BELLAIRE PROPERTIES INC. (CARSON'S CREEK)
PURCHASER EXTRAS

LOT # 062 P.E #004 – Model - CARLYLE - 3080 - PHASE 5

Schedule B-3 – Purchaser’s Extras
forming part of the Agreement of Purchase and Sale

PURCHASER(S): Nosheen Nazir
LOT NUMBER: 062 PHASE: 5
MODEL: 3080 CARLYLE – 2 CAR
P.E.#: 004

FIRST FLOOR
ELEVATION A & B

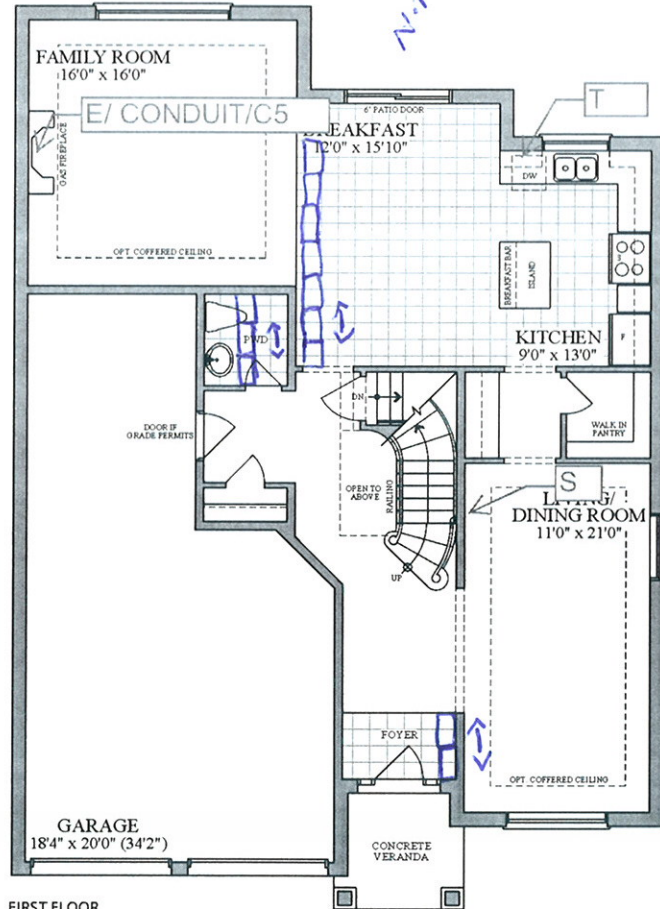
No.	DESCRIPTION	PRICE
1.	Provide stain to stairs, handrail and posts etc. (to complement the colour of hardwood floors) from main to second floor in lieu of standard. Price is based on metal pickets.

2.	Provide and install level 5 floor tiles in the kitchen/breakfast area in lieu of level 1 floor tiles. Note: Tiles to be installed stacked	
3.	Provide and install level 5 floor tiles in the foyer in lieu of level 1 floor tiles. Note: Tiles to be installed stacked

4.	Provide and install level 5 floor tiles in the powder room in lieu of level 1 floor tiles. Note: Tiles to be installed stacked	
5.	Provide and install upgrade stone counter top (level 5) kitchen counter in lieu of level 1.

6.	Provide and install level 5 floor tiles in the mud room in lieu of level 1 floor tiles. Note: Tiles to be installed stacked	
7.	Provide and install upgrade under mount sink in the kitchen area in lieu of standard.	
		Extra's Subtotal:
		H.S.T.
		New Total:
		Less Bonus Package (if Applicable)
		TOTAL:
		TOTAL BALANCE DUE
		TOTAL
